DRAINAGE CONDITION DISCHARGE

Document Reference. 21458-CCL-LS-002

Planning Application No	137467/JO/2023
Site Location	32-34 Laystall Street, Manchester.
Description	Erection of 9 storey residential building (Use Class C3) comprising 89 residential units (28 x 1 bed and 61 x 2 bed) and conversion of and 3 storey extension to 32-34 Laystall Street for use as offices (Class E) with associated external works following demolition of outrigger and associated structures along with other associated works including access, servicing, landscaping and secure cycle parking.
Applicant Name	Great Places Housing Group

LLFA Drainage comments.

5. Drainage Details

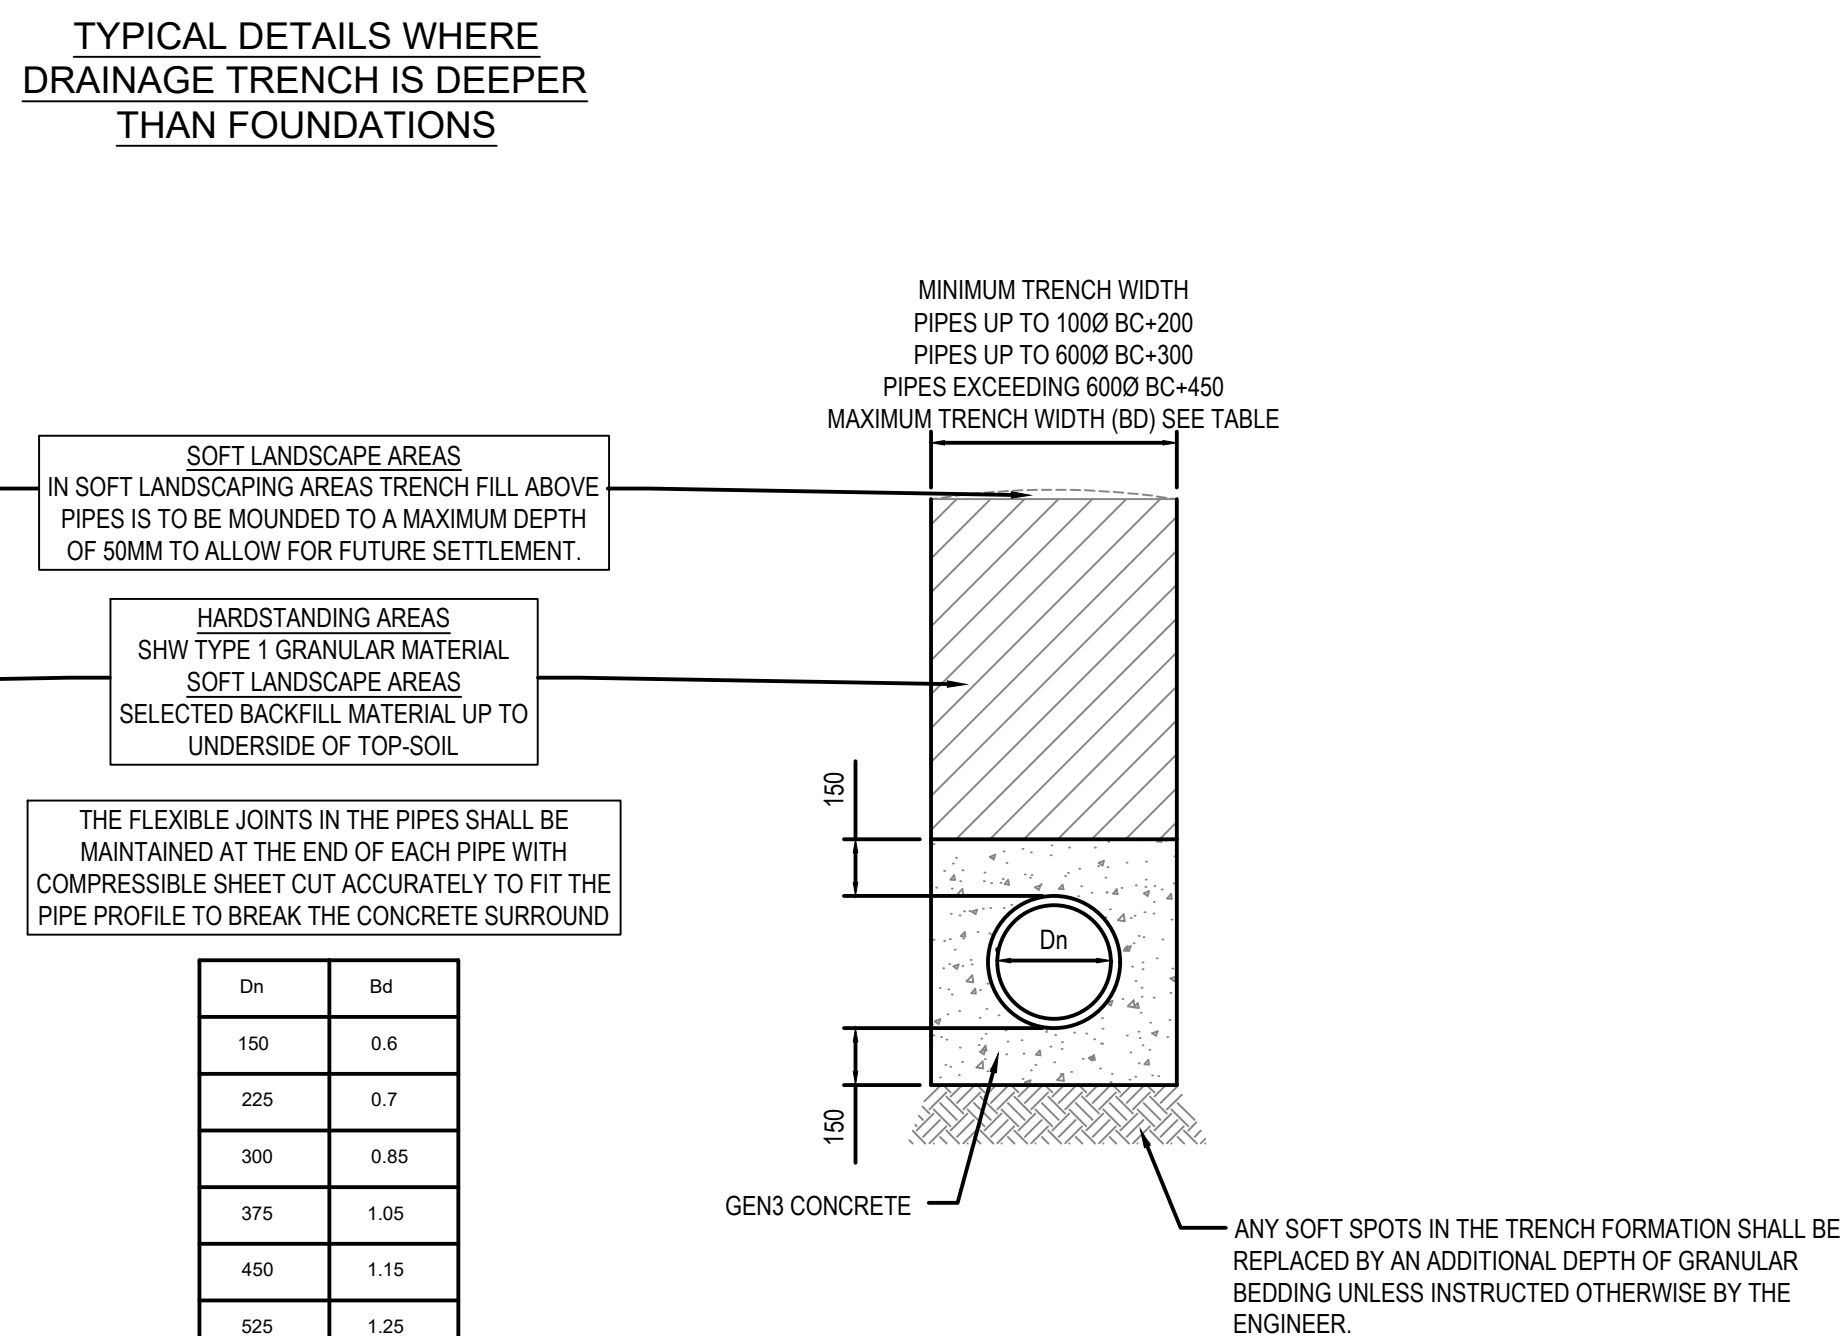
5. Assessment of overland flow routes for extreme events that is diverted away from buildings (including basements). Overland flow routes need to be designed to convey the flood water in a safe manner in the event of a blockage or exceedance of the proposed drainage system capacity including inlet structures. A layout with overland flow routes needs to be presented with appreciation of these overland flow routes with regards to the properties on site and adjacent properties off site.

Refer to Overland Flow Path drawing appended to the back of this document.

With regards to the courtyard area, given that the basement level is c.1.5m below road level (Brock Street), should a blockage occur preventing surface water discharge, the basement could potentially receive flood water. Given the impermeable catchment size of this area (94m²), this has been considered as low risk. Providing maintenance of on-site drainage is carried out in accordance with the drainage maintenance strategy, and United Utilities maintain their public sewer assets, the risk to flooding due to blockage has been considered as low risk.
